## REQUEST FOR INFORMATION

Request for Information -	001	ROUTING	DATE SENT	VIA MAIL, EMAIL OR FAX			DATE	VIA MAIL, EMAIL OR FAX		
-				М	Ε	F	RECEIVED	FD W	Е	F
OWNER: LFMSDD		Contractor to Engineer	1/17/2011		Х		01/17/11		Х	
PROJECT: HDTRWRF		Engineer to Contractor	1/17/2011		Х					
ENGINEER: GMS, Inc.		Copy to Owner	1/17/2011		Х					
CONTRACTOR: Weaver Gener	al Constructio	on Co.								
RFI TITLE: Curb Detail								•

REFERENCE: Drawing 3/AB-4

KEYWAY DETAIL

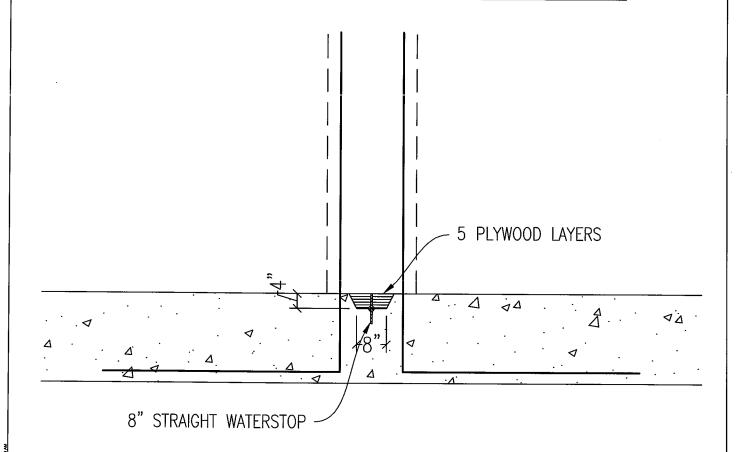
Baker Concrete proposes to utilize the attached curb detail for Aeration Basins 1, 2 and 3. Is this acceptable?

BCCI PROPOSES TO PLACE A REGULAR KEYWAY INSTEAD OF INVERTED KEYWAY & REMOVE CURB.

The proposed detail does not provide for a curb section. We request the curb be constructed in accordance with Detail 3/AB-4 on Sheet AB-4 of the Construction Drawings.
